Fwd: Dualband feedhorn

Subject: Dualband feedhorn

I think I have a good design for a dual-band feedhorn. Performance curves and dimension sketches attached. I drew it as two pieces, which is the way one would machine it to minimize the amount of aluminum to be removed.

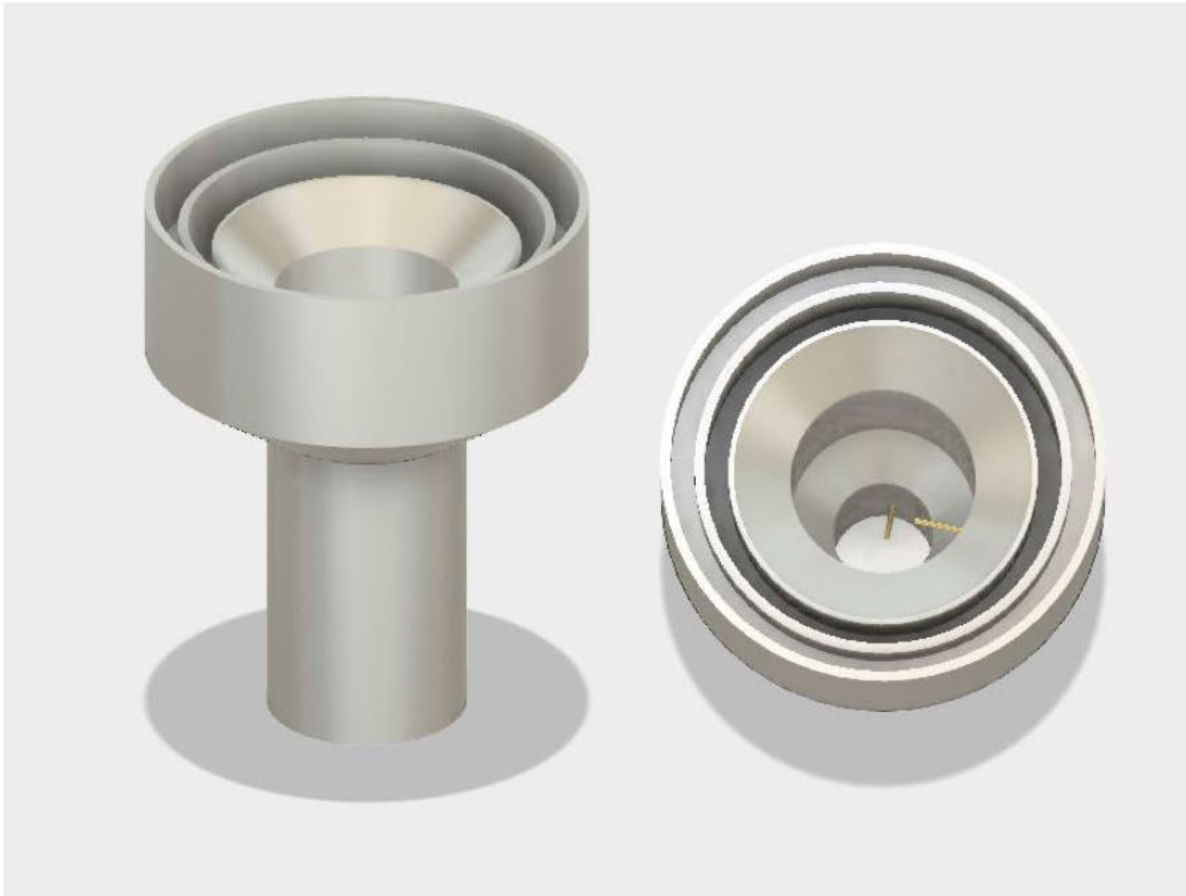
1. Should the top edges of the feed body be tapered to smoothly join with the taper of the horn? I guessed yes. The drawing shows the edges flat-topped, and doesn't specify exactly how it aligns with the horn.

2. Do you expect the bottom end plate to be integral with the feed body, or a separate bolted-on plate for access?
3. How do you envision the horn being attached to the feed body?
4. Do you envision using standard SMA connector with a four-hole square flange, like Amphenol 132146, or some other kind of connector?

How smooth do the tapered parts need to be?

I drew it with a flat edge on the body, just to simplify machining, with the edge even with the horn taper. if it were one piece, I'd just extend the taper.

no real need for access, but it might be useful to have it separate as a mounting plate. again, easier to machine a thru hole and use a reamer to make it smooth

sliding fit with a couple of set screws.

yes, a four-hole square flange with a long pin

the tapers inside should be reasonably smooth. if 3D printing, that would be an interesting test, but a few mils roughness shouldn't be bad
